# Access Compliance Report Public Rights-of-Way (Curb Ramps)

Intersection ID: 51970	Main Street: CAMPBELL COMMONS WY	Cross Street: BALLANTYNE COMMONS PY	Location:	N
ADA ID: 71493BB4E33D	Ramp Type: Directional1	Initial Pass/Fail: Fail	Overall Compliance: No	Severity Score: 12.5

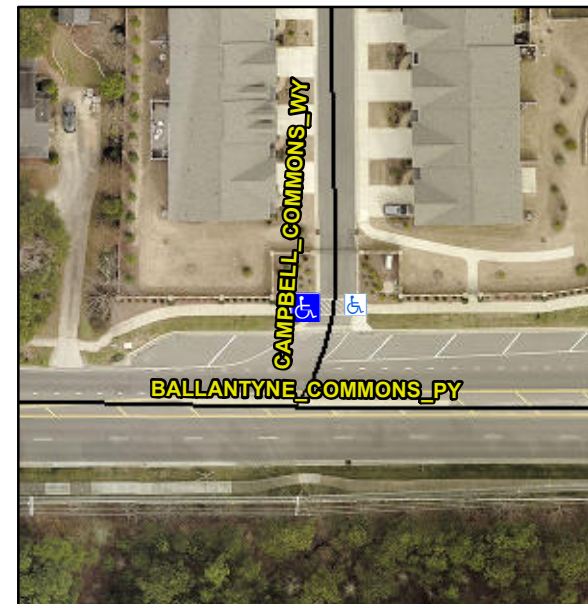
Compliance	Description	Data	Compliance	Description	Data
N/A	Ramp Length (in)	88.0	N/A	Grade Break?	N/A
Yes	Ramp Width (in)	48.0	N/A	Grade Break Slope (%)	0.0
Yes	Ramp Slope (%)	7.9	N/A	Grade Break XSlope (%)	0.0
No	Ramp XSlope (%)	6.7			
N/A	Flare Type LT	N/A	N/A	Flare Type RT	N/A
N/A	Flare Slope LT (%)	N/A	N/A	Flare Slope RT (%)	0.0
N/A	Flare Traversable LT?	N/A	N/A	Flare Traversable RT?	N/A
N/A	Landing Length (in)	0.0	N/A	DWS Provided?	N/A
N/A	Landing Width (in)	0.0	N/A	DWS Contrast?	N/A
N/A	Landing Slope (%)	0.0	N/A	DWS Length (in)	N/A
N/A	Landing X Slope (%)	0.0	N/A	DWS Full Width?	N/A
N/A	Landing Curb? (Y/N)	N/A	N/A	DWS Offset LT (in)	N/A
N/A	Shared Landing?	N/A	N/A	DWS Offset RT (in)	N/A
N/A	Gutter Ponding?	0.0	N/A	Gutter Slope (%)	N/A
N/A	Gutter Lip Ht (in)	0.0	N/A	Gutter X Slope (%)	N/A
N/A	Painted X Walk1?	Yes		Road Slope (%)	2.8
	X Walk 1 Direction	To NE		Road X Slope (%)	2.0
	X Walk 1 Width (in)	91.5		Clear Space?	N/A

**Remove & Replace Entire Ramp.**
